FIELD SERVICE CAMPAIGN – 20113

Cummins® X15 Idler Pulley Bracket Bolts

International® HX® Series Trucks

Figure 1. Idler Pulley Bracket Assembly

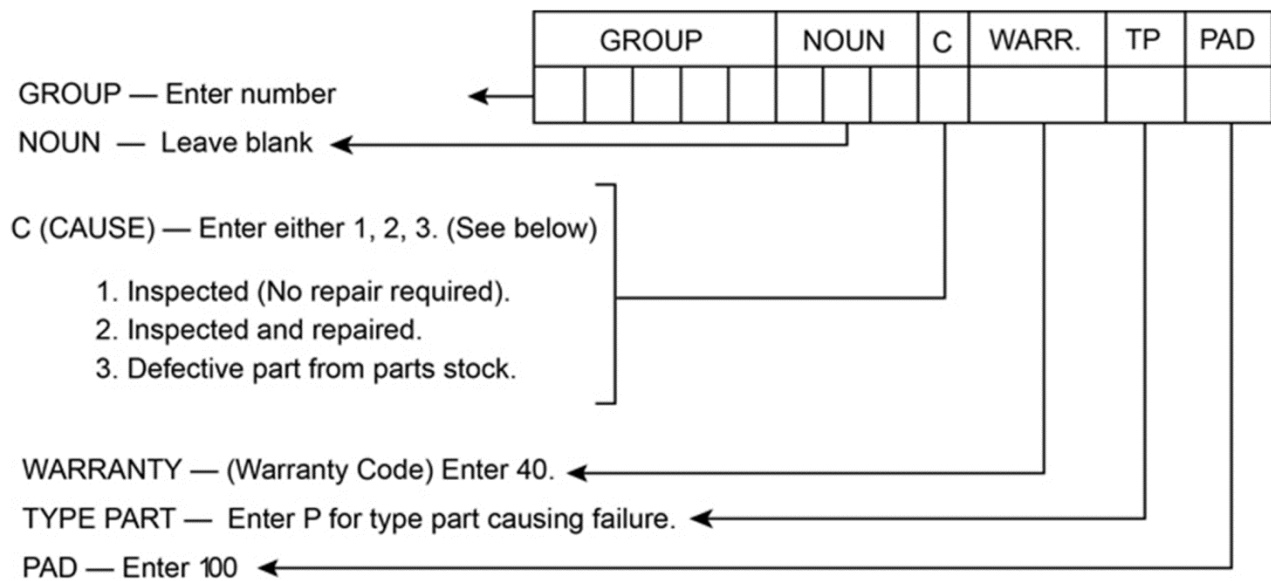
For certain International® HX® Series trucks with Cummins® X15 engines, the bolts that attach the idler pulley mounting bracket may not be long enough to attain the correct clamp load and may result in the mounting bolts to loosen or fracture. All other vehicles built during this period have either been repaired prior to shipment or determined to not require this repair.

7. Remove three bolts and lock washers (Figure 1, Item 1) that fasten idler pulley bracket (Figure 1, Item 2) to engine. Discard bolts and washers.

8. Install idler pulley bracket (Figure 1, Item 2) using new bolts and lock washers (Figure 1, Item 1). Ensure P-clip (Figure 1, Item 3) is installed under bracket stand-off leg and bolt is placed through eyelet.
9. Using torque wrench, tighten bolts to 19-21lb-ft (25.9-28.8 N•m).
10. Reinstall accessory drive belt.
11. Close and latch hood.
12. Remove wheel chocks.
